### CORRIGENDUM-III

#### RFP ENQ. No.- OCAC-NEGP-INFRA-0007-2021-22061 Dated 23.08.2022, for Selection of Agency for Implementation, Operations and Maintenance of OSWAN NOC

### **6.3. OSWAN-NOC Layout:**

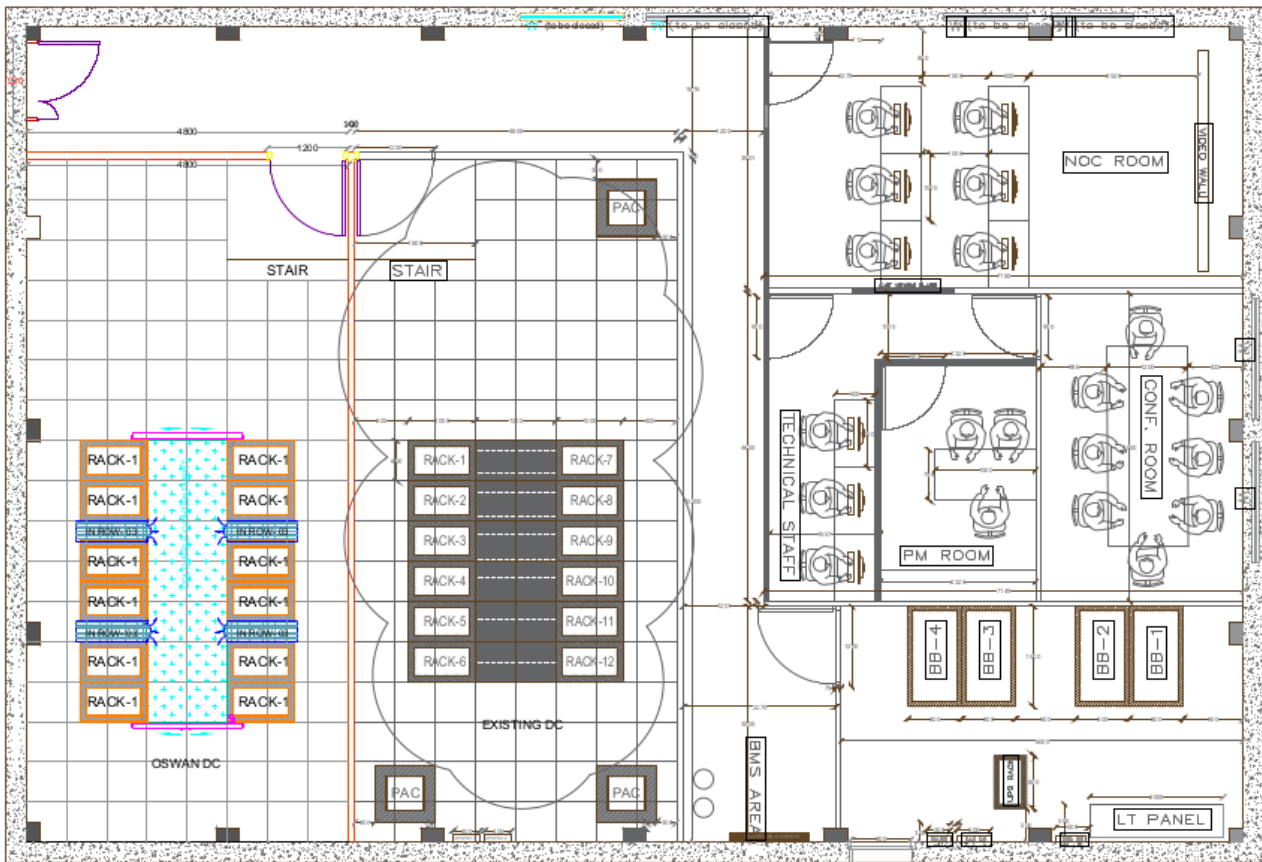
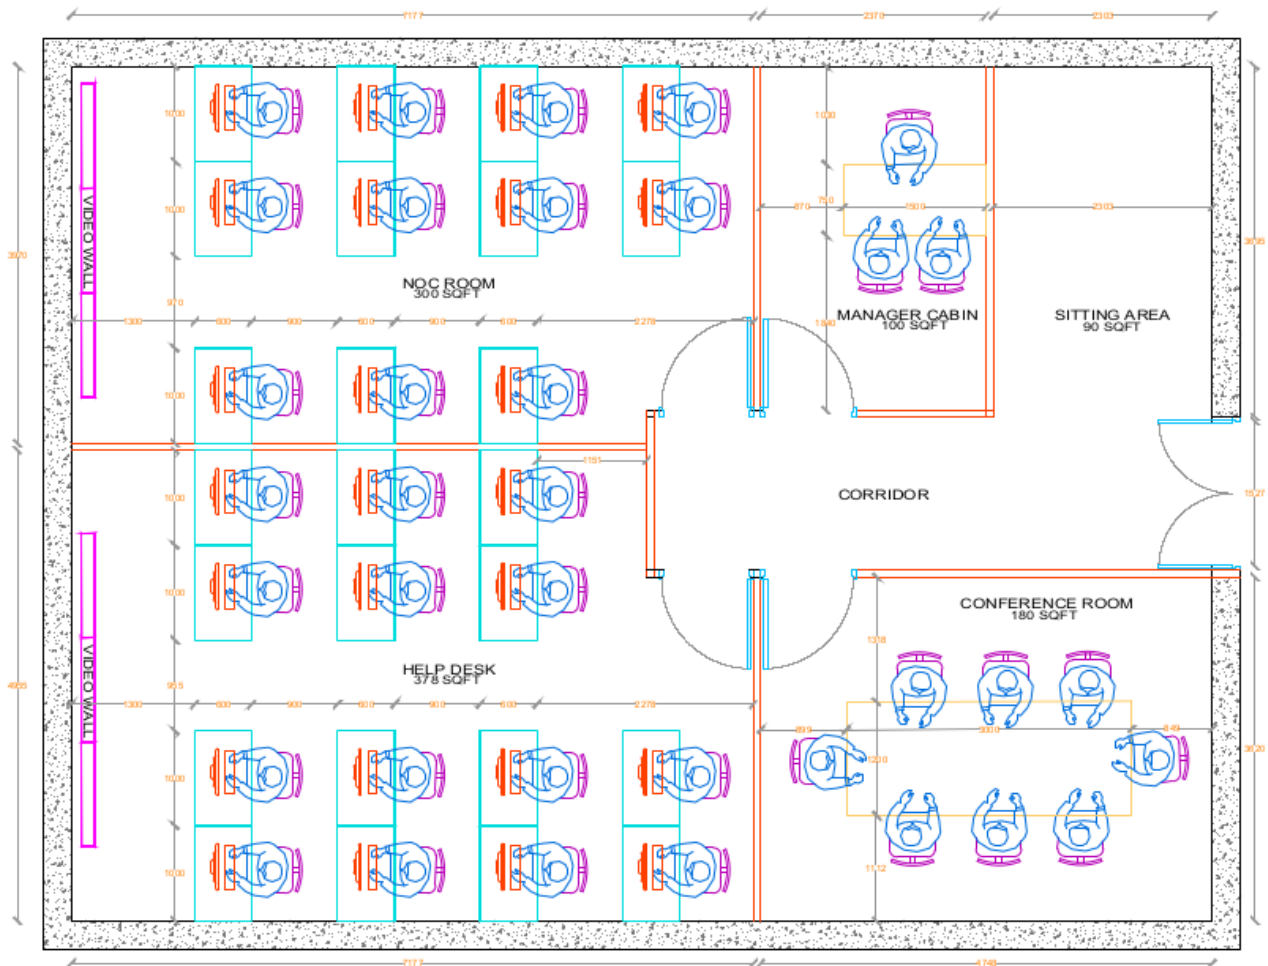
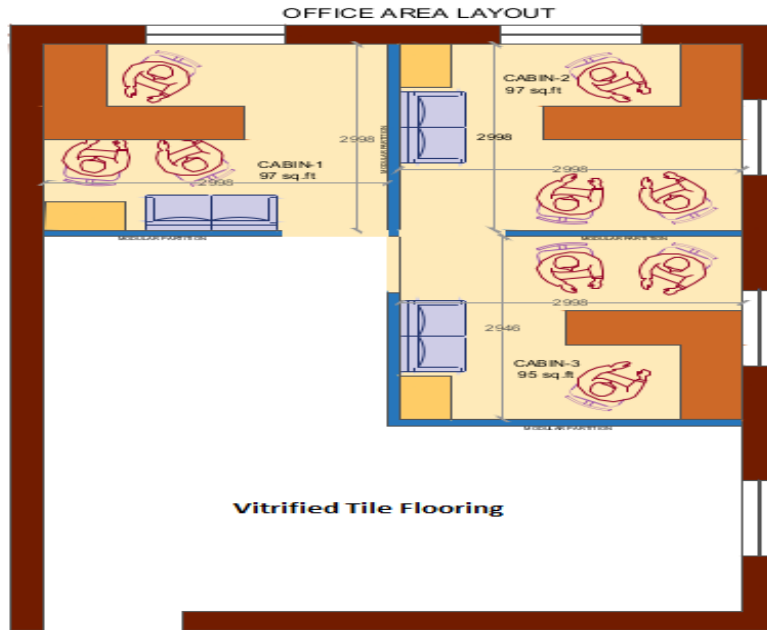
Sr. No.	Page No	Clause No	RFP Clause	Query /Clarification/ Suggestion if any asked		Modification/ Addendum/ Deletion/ Clarification
107.	36,37		The diagrams and layout are on the page 36 and 37	Is OSWAN NOC Room, Office Area Layout and OSWAN Helpdesk Room is final as per the OSWAN RFP doc ?		<b>Clarification:</b> It may change as per the space availability and as best practice of bidder solution.
